Joint Development Authority
TCAAP Redevelopment Project

SUBJECT: Consider Recommendation of TRC Amendment Requests

RCC Proposed Amendments - TCAAP Redevelopment Code

Date: March 6, 2026
 To: John Mazzitello, Larina DeWalt – Ramsey County
 From: Eric Fosmo, Michael Kirsch – Kimley Horn

PEDESTRIAN LIGHTS:
 HEIGHT = 18 FT
 POLE STYLE = B - COLUMBUS
 POLE COLOR = BLACK
 LED LUMINAIRE STYLE = LANTERN
 LUMINAIRE COLOR = BLACK
 PLAN SYMBOL:

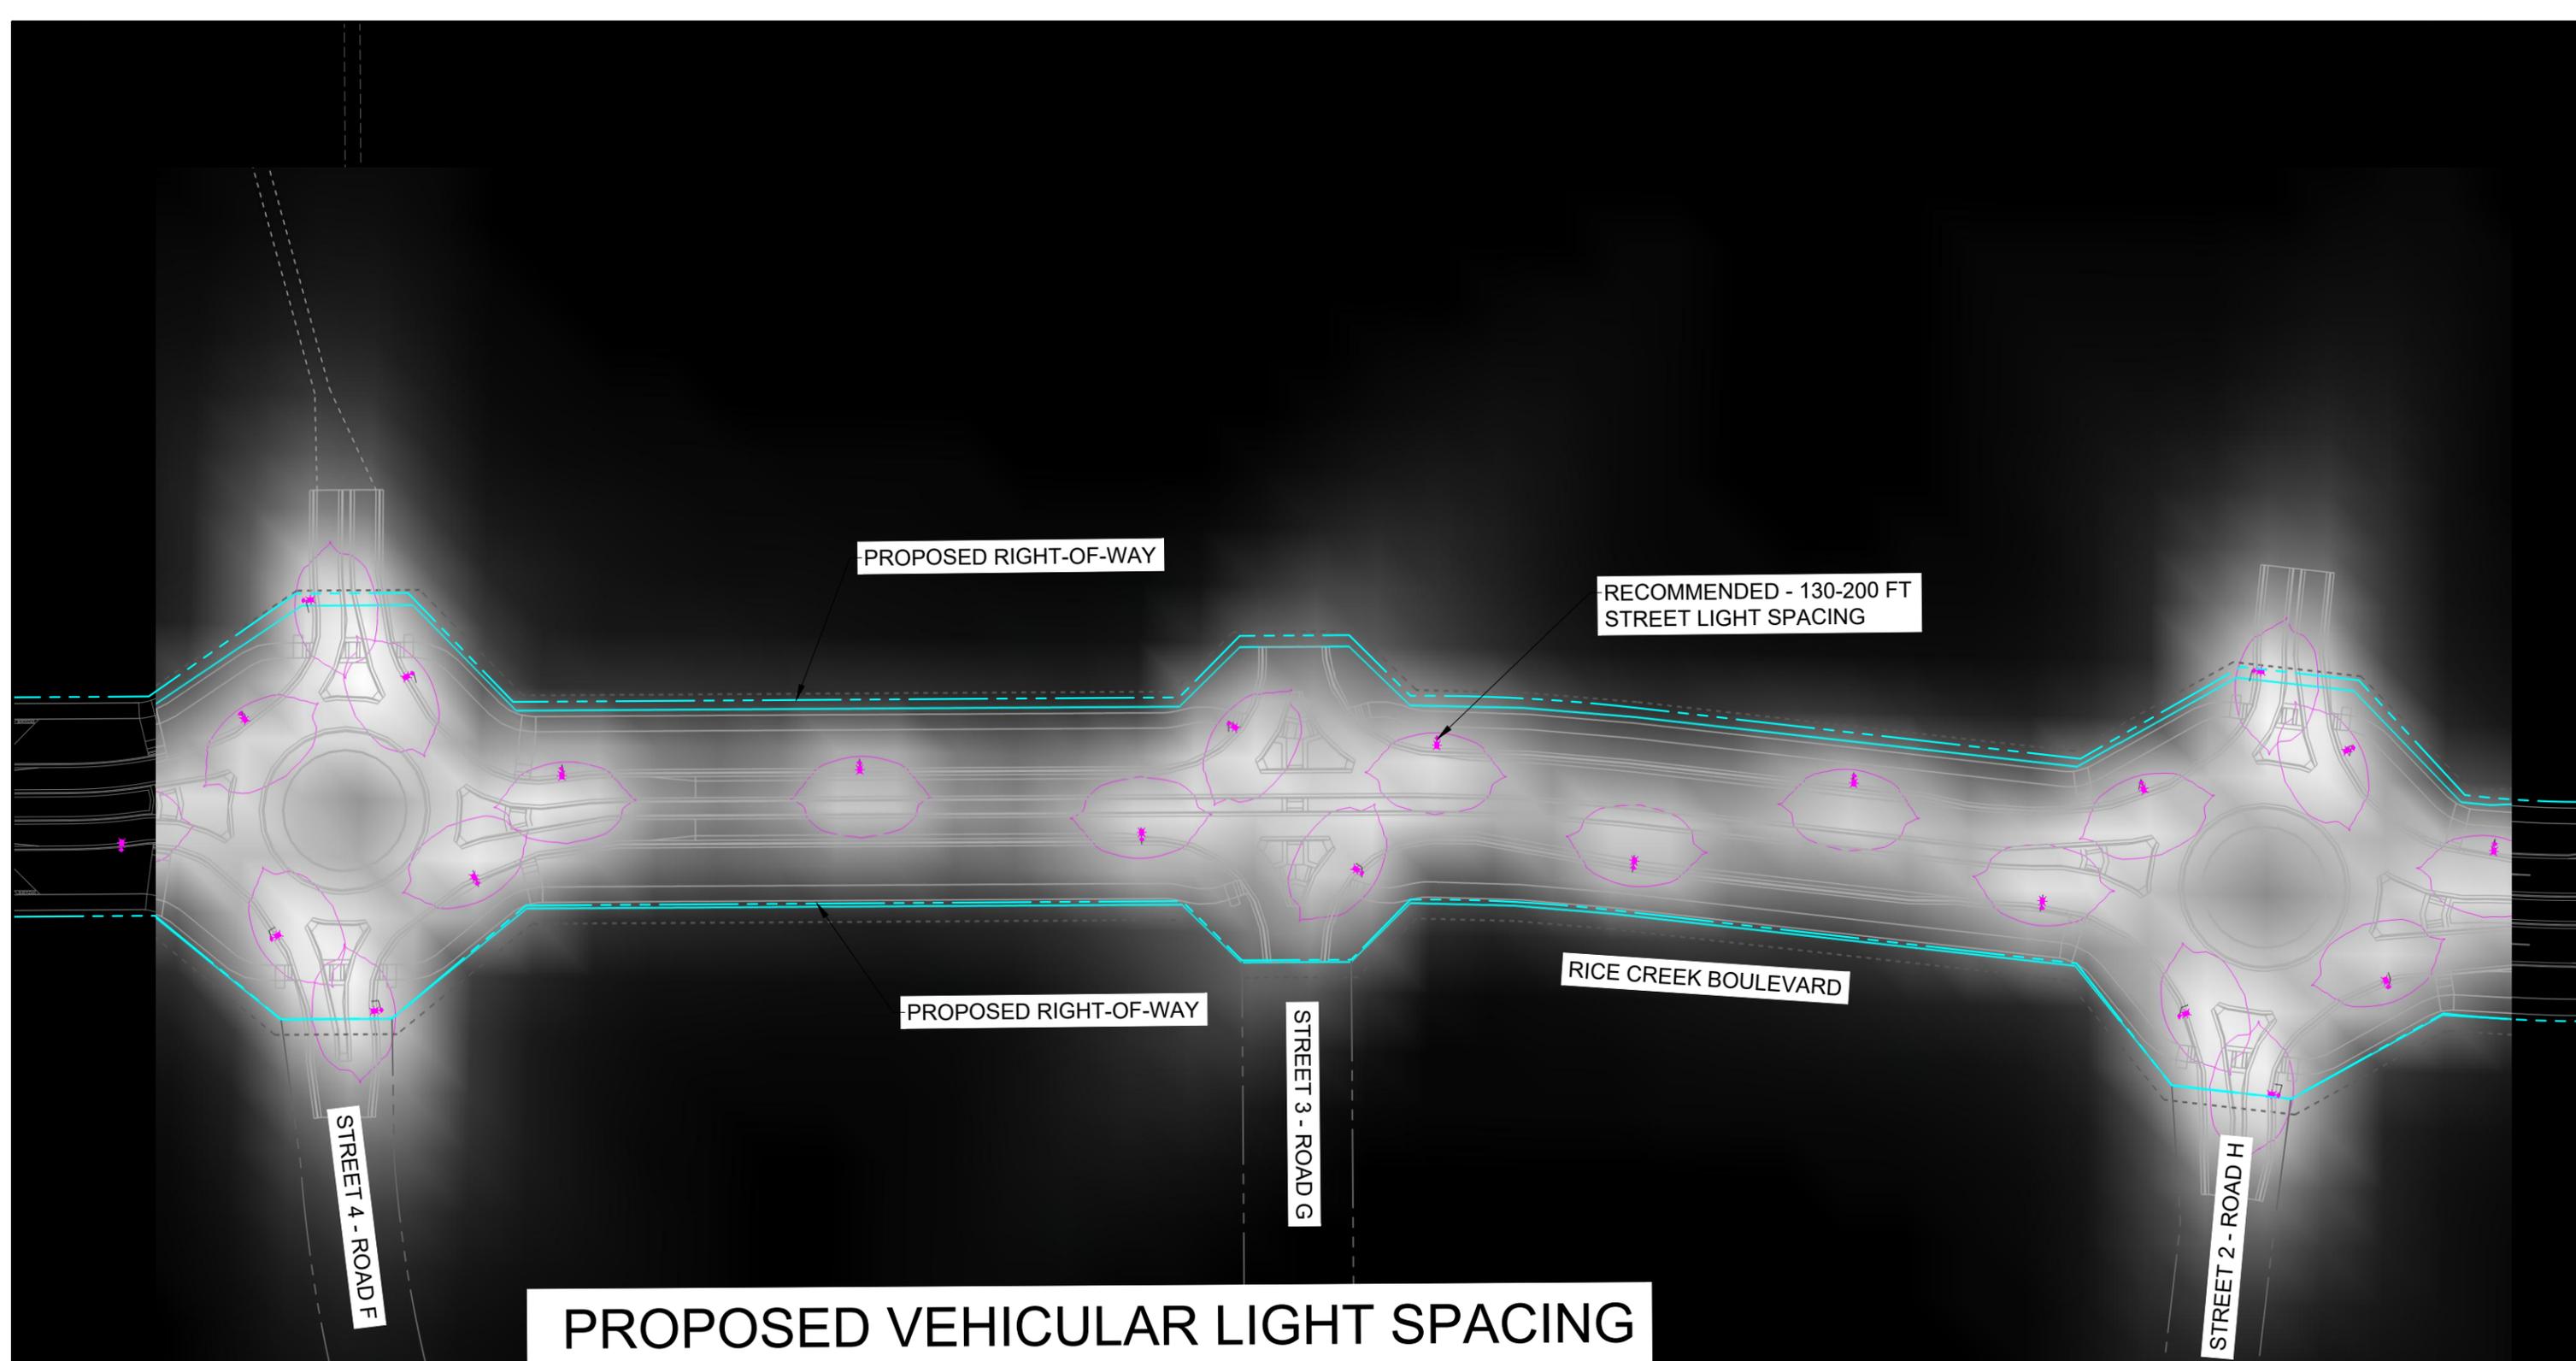
As written, the applicable code appears to allow for an approach where no lighting would be required along Rice Creek Boulevard. However, this approach would not be consistent with best safety practices nor City/County design precedence at the proposed roundabout intersections. The need to provide intersection lighting does not allow for compliance with the TRC through providing no lighting along Rice Creek Boulevard.

Roundabout Lighting: MnDOT and FHWA design guidance recommends that all roundabouts be lit to provide adequate visibility for all modes of transportation during non-daylight hours. This guidance is consistent with past precedence for roundabouts constructed by Ramsey County and the City of Arden Hills.

Vehicular Lighting: 40-ft Spacing

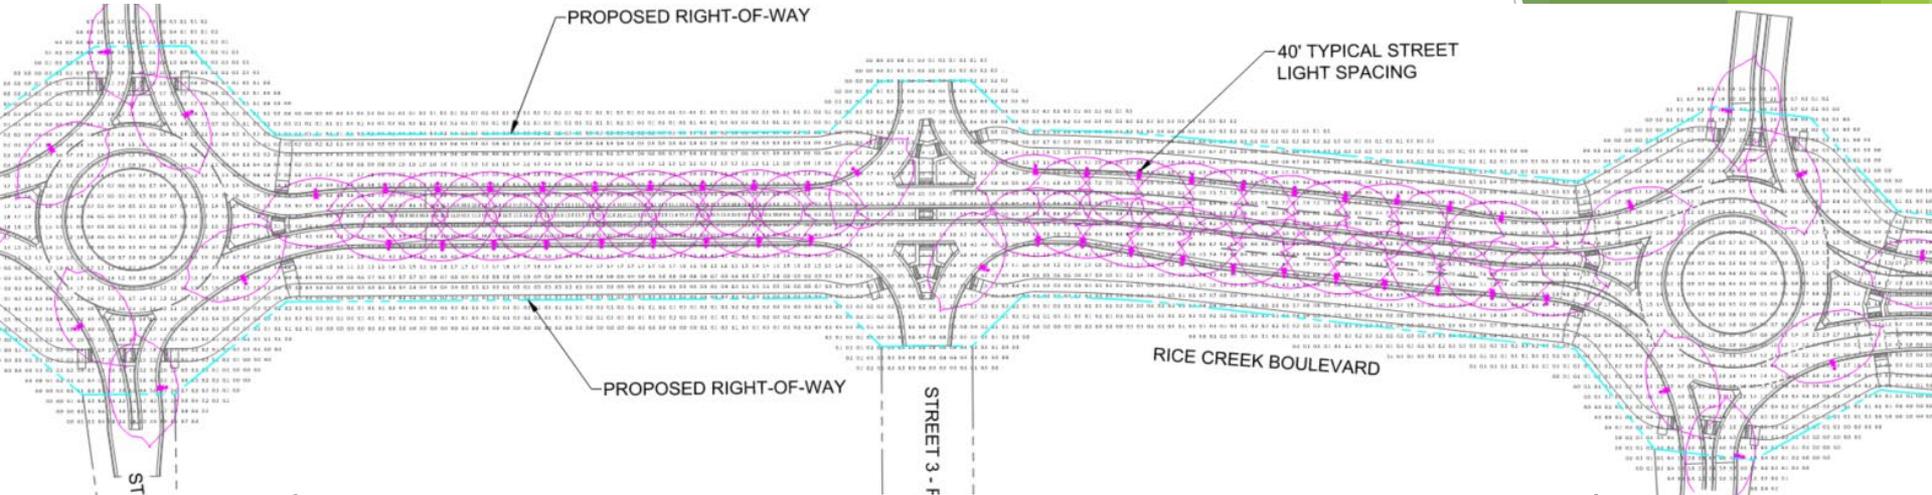
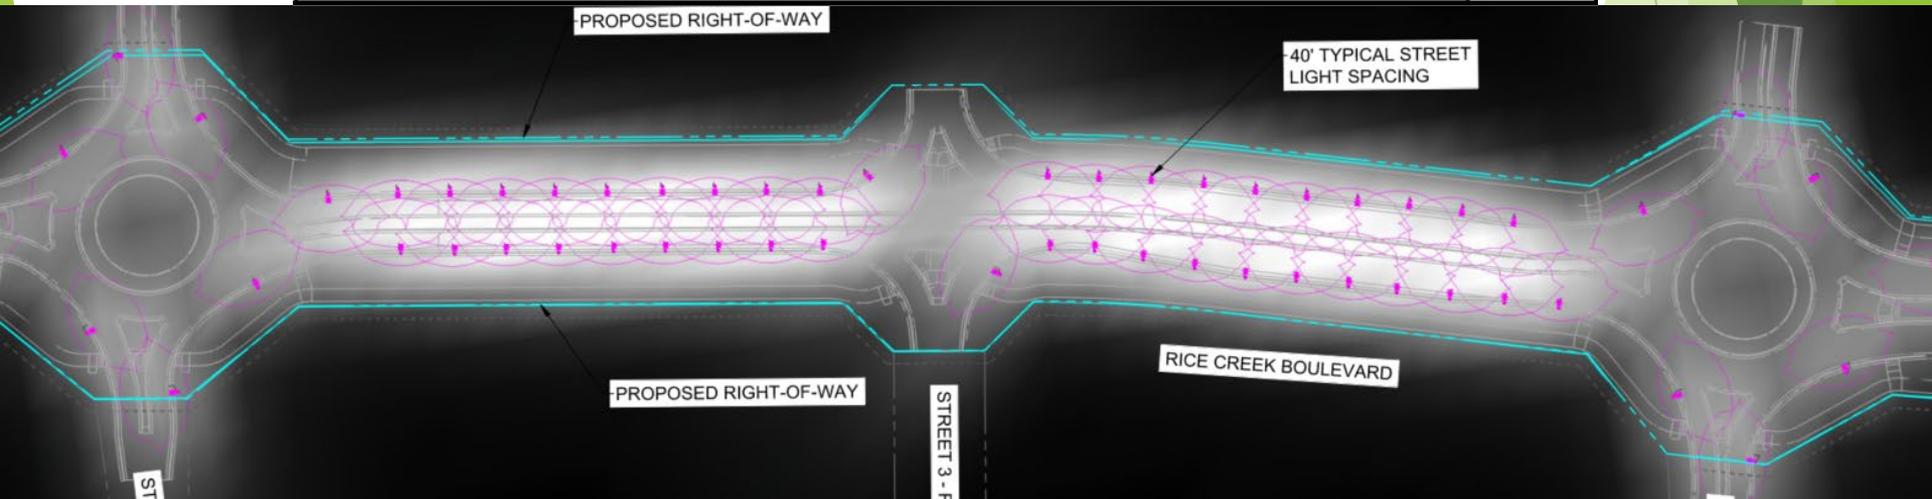
FOOT CANDLE LEVELS - 40 SPACING (PER TRC)				
LOCATION	AVG. ILLUMINANCE (Fc) RECOMMENDED	AVG. ILLUMINANCE (Fc) AS DESIGNED	UNIFORMITY (Avg/Min) RECOMMENDED	UNIFORMITY (Avg/Min) AS DESIGNED
ROADWAY	1.0	7.32	4.0	1.44
TRAIL	2.0	0.55	3.0	1.83
MAXIMUM ALLOWABLE ILLUMINANCE AT ADJOINING RESIDENTIAL PROPERTY (PER CITY CODE 1325.05)				0.4
MAXIMUM ILLUMINANCE AT ADJOINING RESIDENTIAL PROPERTY				N/A

Vehicular Lighting: Proposed Design

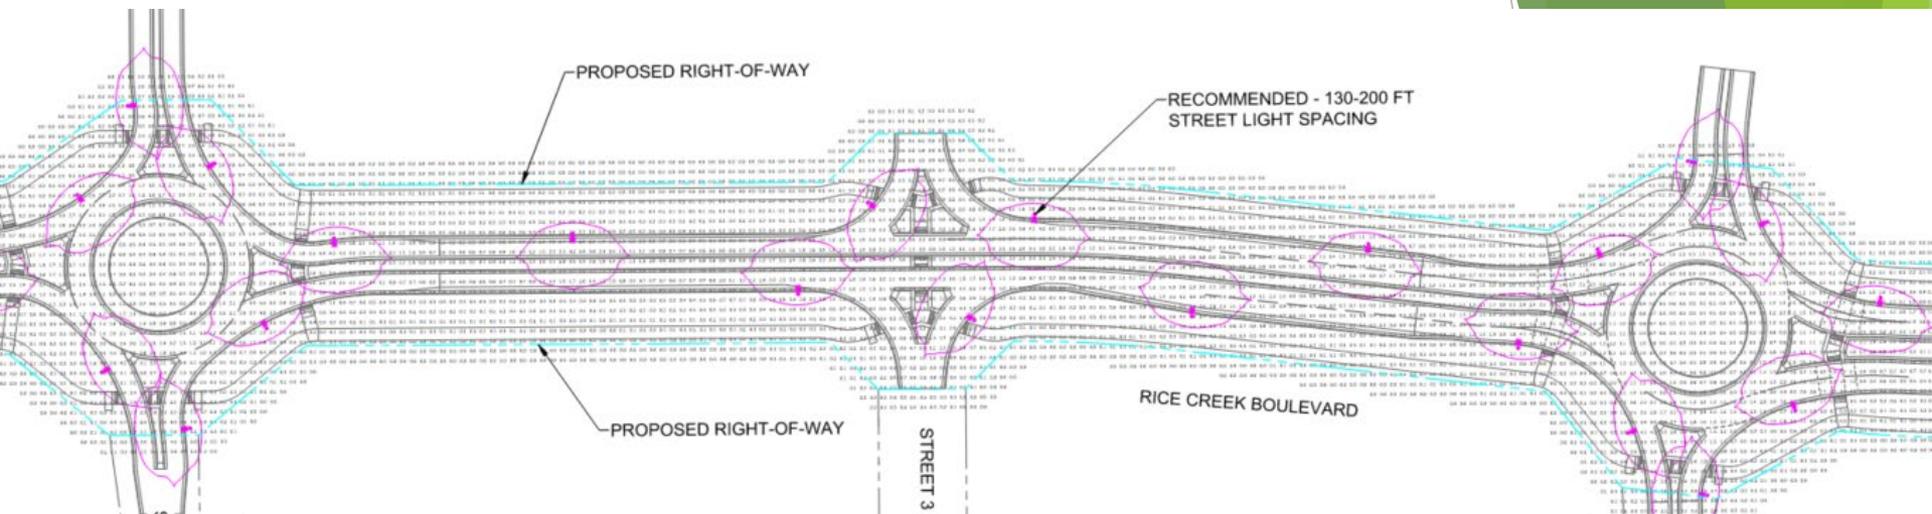
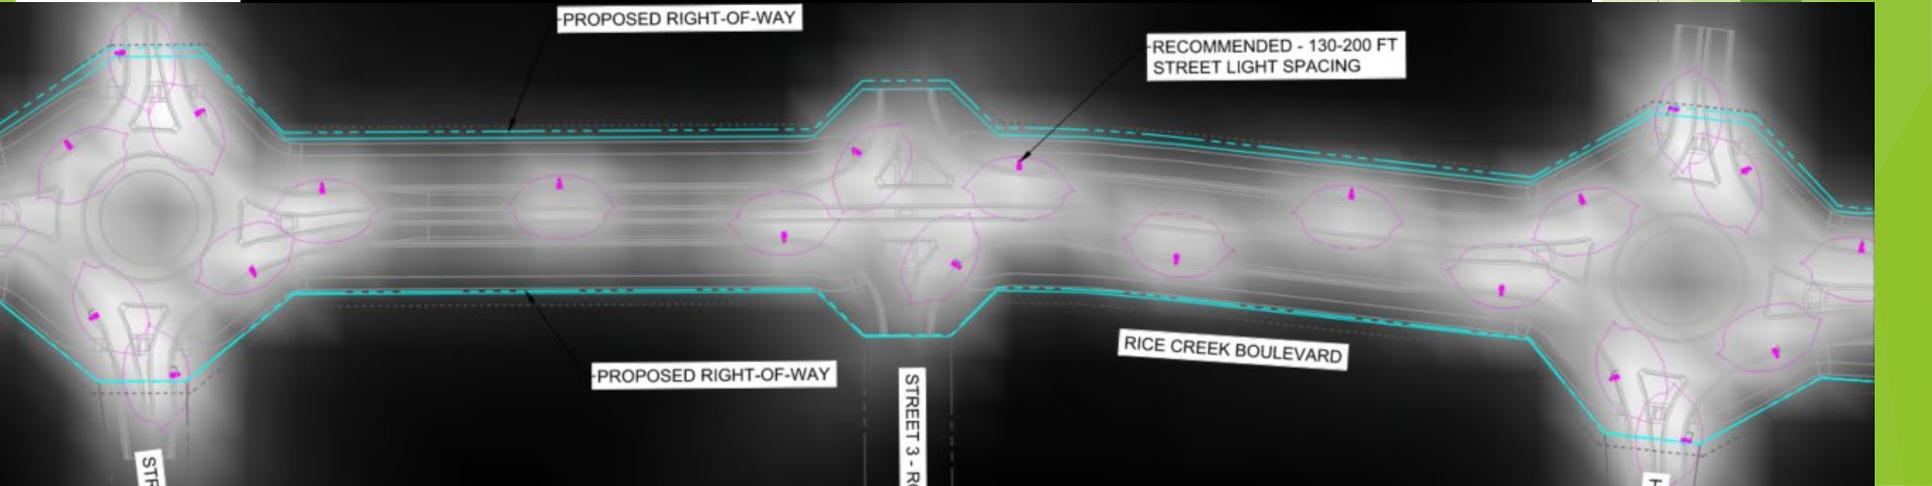
LOCATION	AVG. ILLUMINANCE (Fc) RECOMMENDED	AVG. ILLUMINANCE (Fc) AS DESIGNED	UNIFORMITY (Avg/Min) RECOMMENDED	UNIFORMITY (Avg/Min) AS DESIGNED
ROADWAY	1.0	1.20	4.0	3.00
TRAIL	2.0	0.06	3.0	N/A
MAXIMUM ALLOWABLE ILLUMINANCE AT ADJOINING RESIDENTIAL PROPERTY (PER CITY CODE 1325.05)				0.4
MAXIMUM ILLUMINANCE AT ADJOINING RESIDENTIAL PROPERTY				N/A

Pedestrian Lighting: Potential Design

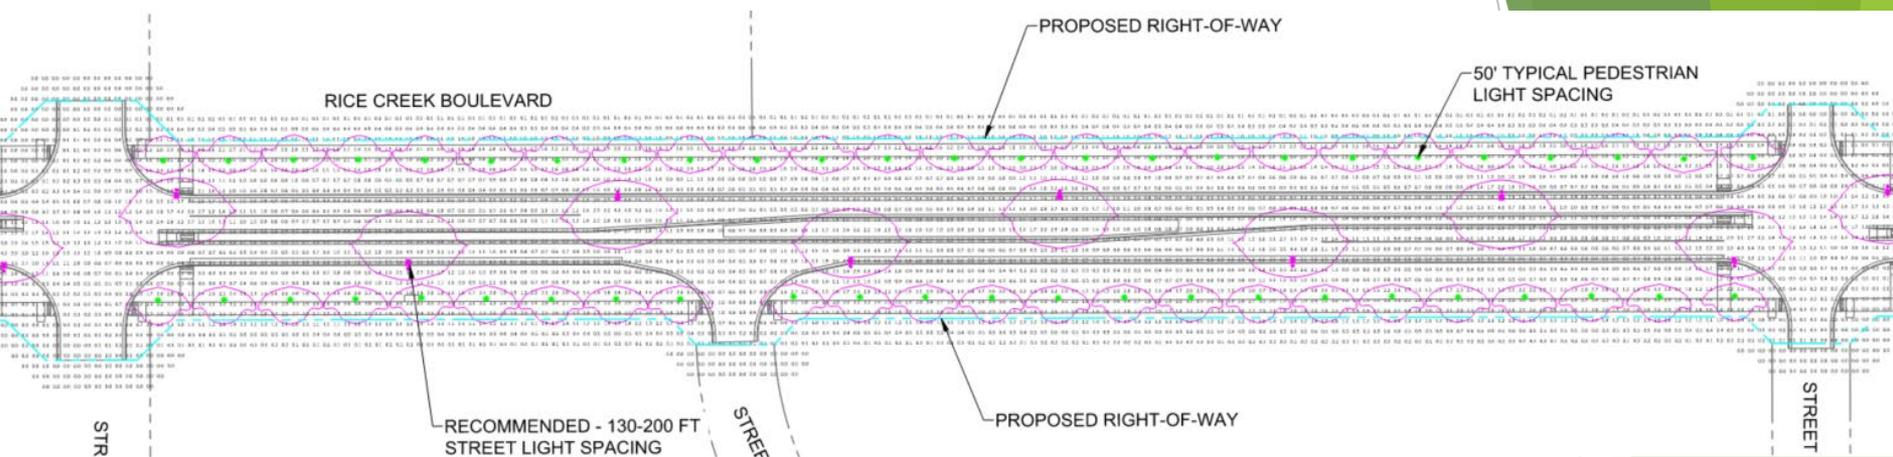
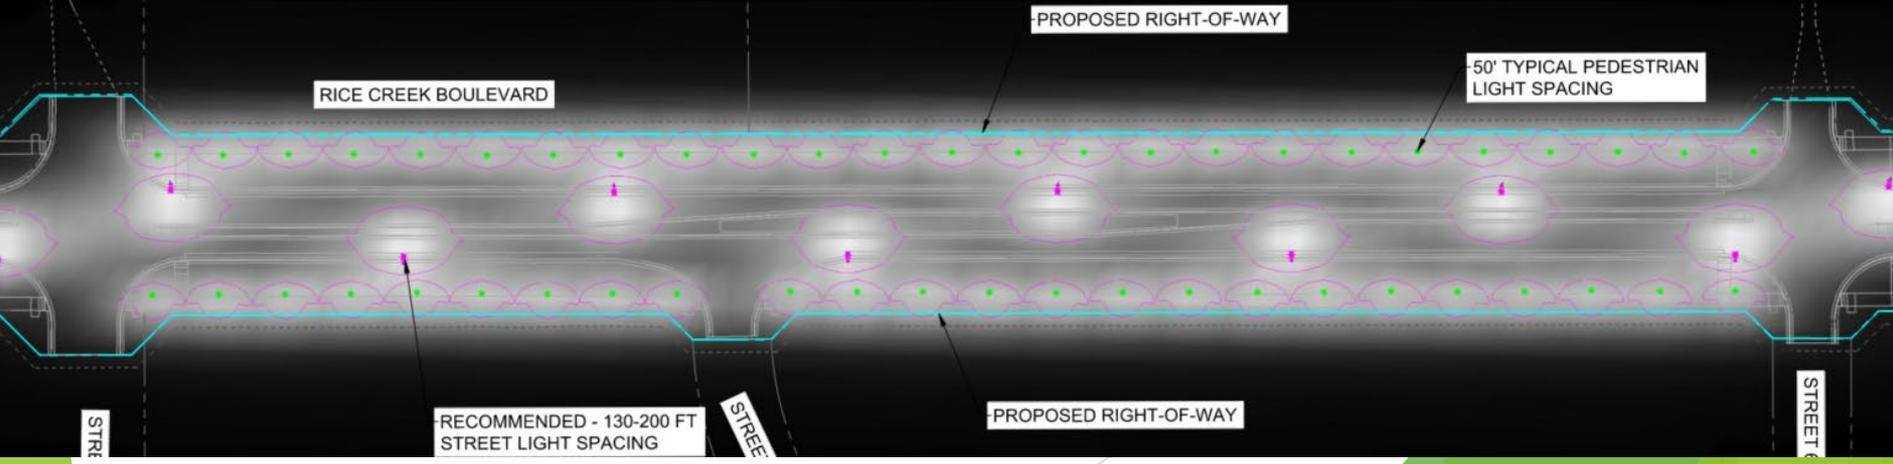
FOOT CANDLE LEVELS - AMENDED SPACING (PHOTOMETRIC DESIGN) - WITH PEDESTRIAN LIGHTS				
LOCATION	AVG. ILLUMINANCE (Fc) RECOMMENDED	AVG. ILLUMINANCE (Fc) AS DESIGNED	UNIFORMITY (Avg/Min) RECOMMENDED	UNIFORMITY (Avg/Min) AS DESIGNED
ROADWAY	1.0	1.07	4.0	2.68
TRAIL	2.0	2.16	3.0	1.44
MAXIMUM ALLOWABLE ILLUMINANCE AT ADJOINING RESIDENTIAL PROPERTY (PER CITY CODE 1325.05)				0.4
MAXIMUM ILLUMINANCE AT ADJOINING RESIDENTIAL PROPERTY				1.9
